# GTS NEWSLETTER

## TASKI ergodisc – Dispensing unit

### Optimisation around the spray nozzle

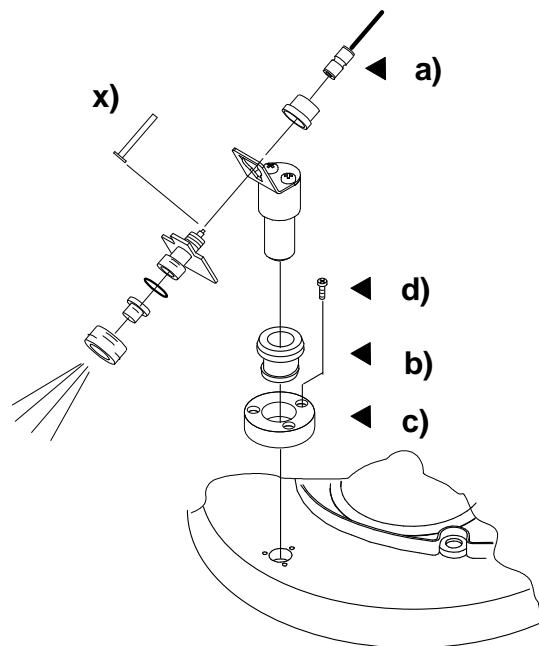
1. Practical experience showed that the hose is often separated from the spray nozzle or then positioned differently. To simplify this separation you will now find a so-called “quick connector”\* **a)** order No. 4123157 (2744/081) behind the nozzle body. (Quick-release by pressing onto the face side)  
This new concept needs additionally a 50 mm long piece of hose 2/4mm, order No. 4049370 (8722/12), see **x)**.
2. Improved positioning/fixation of the spray nozzle by adding a distance disc **c)**  
Necessary parts:

<b>b)</b> Rubber ring	order No. 4037840 (14501-49)
<b>c)</b> Distance disc	order No. 4123156 (70016-45)
<b>d)</b> PT screw	order No. 4082610 (1840/012)

*Parts a) and c) are new in the TASKI spare parts programme !*

Cut through the hose 50 mm behind the body of the spray nozzle (see **x)**), then push both hose ends into the connector **a)** – that’s it.

Starting immediately, only executions with the new parts will be delivered. The new parts can, at any time, also be retrofitted to existing TASKI ergodiscs/dispensing units.
